**PROPOSED LONG RANGE DEVELOPMENT PLAN
AMENDMENT NO. 7**

ATTACHMENT 7

LONG RANGE DEVELOPMENT PLAN AMENDMENT NO. 7

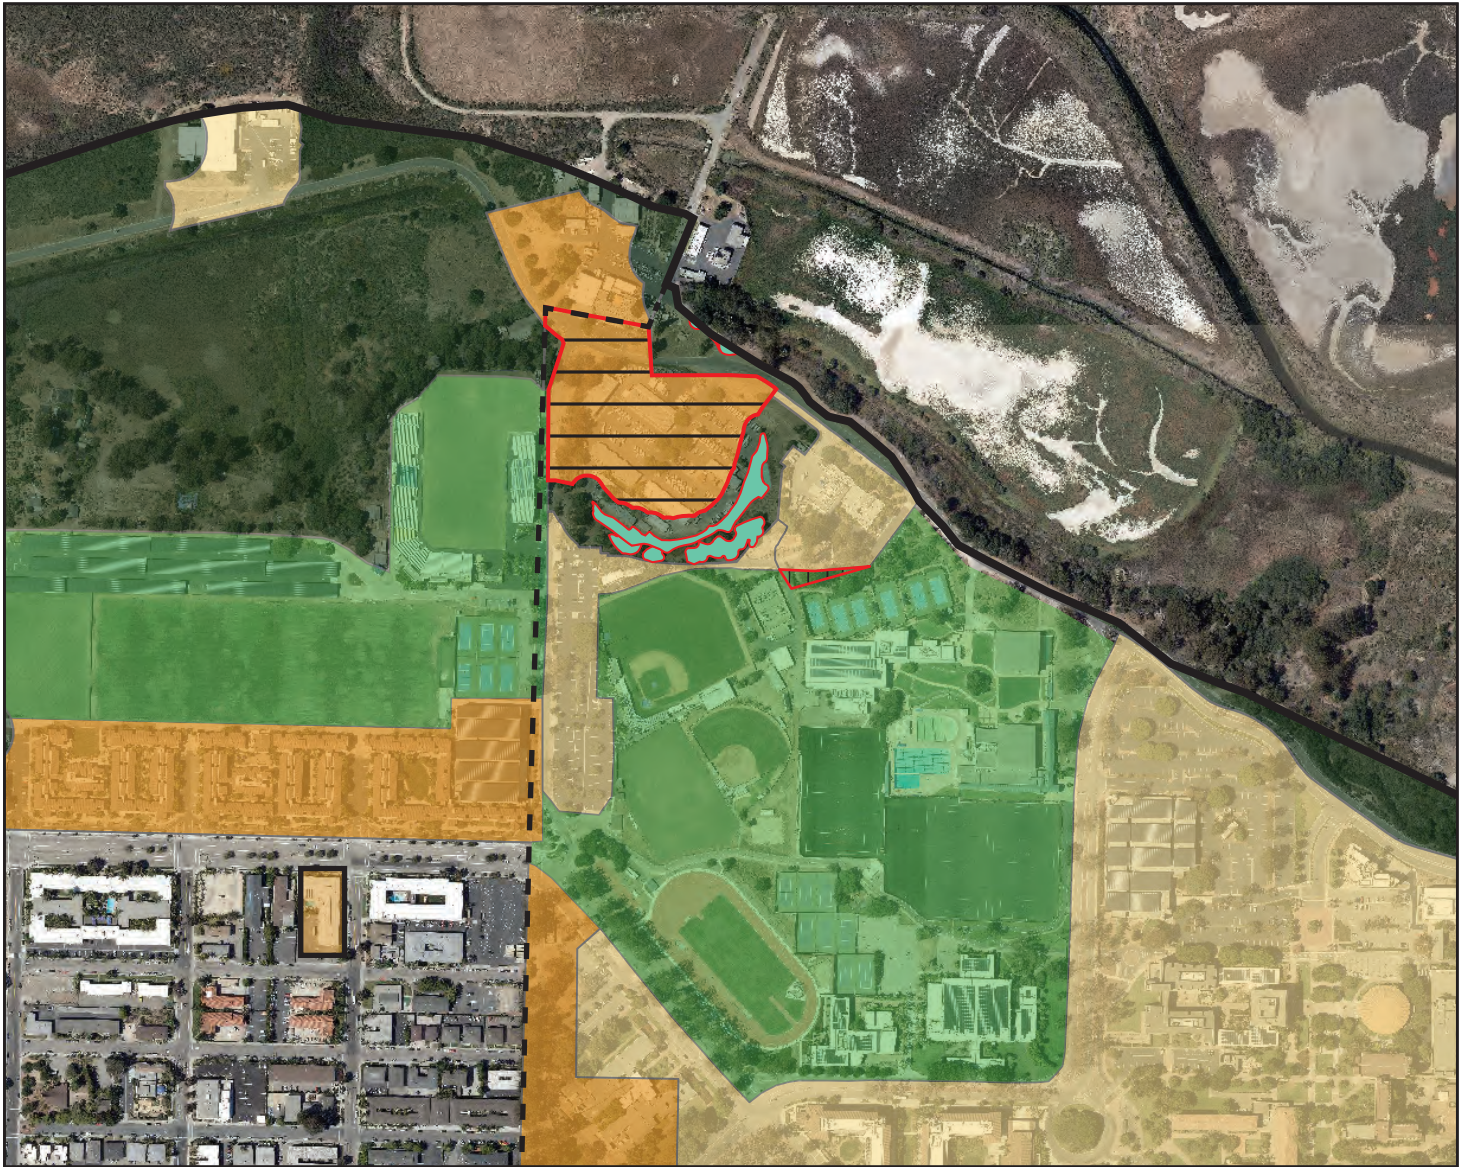
- **Amend 2010 LRDP Figure D.4 (Height Limits) and LRDP Policy LU-10 to increase the maximum building height on the housing project site from 65 to 85 feet.**
- **Amend 2010 LRDP Policy LU-10c to include the project-related parking requirements specified by 2010 LRDP Policy TRANS-15B.**

- **Amend 2010 LRDP Figure D.1 (Land Uses) to change the land use designation of the southern portions of the proposed Central Utility Plant site, and the southern portion of the proposed Lot 17 service vehicle driveway from a “Recreation” land use designation to an “Academic and Support” land use designation. Also, make corresponding changes to Figure D.3 (Potential Development Areas).**

- A maximum of 200 faculty/staff/ family housing units;
- A maximum of up to 2,250 student bed spaces;
- Up to 900,000 GSF development;
- Heights shall not exceed ~~65~~ 85 feet on the southern portion of the site and 35 feet on the northern portion of the site as shown in Figure D.4.;
- Site coverage up to 50 percent; and
- Maximum onsite population of 3,000
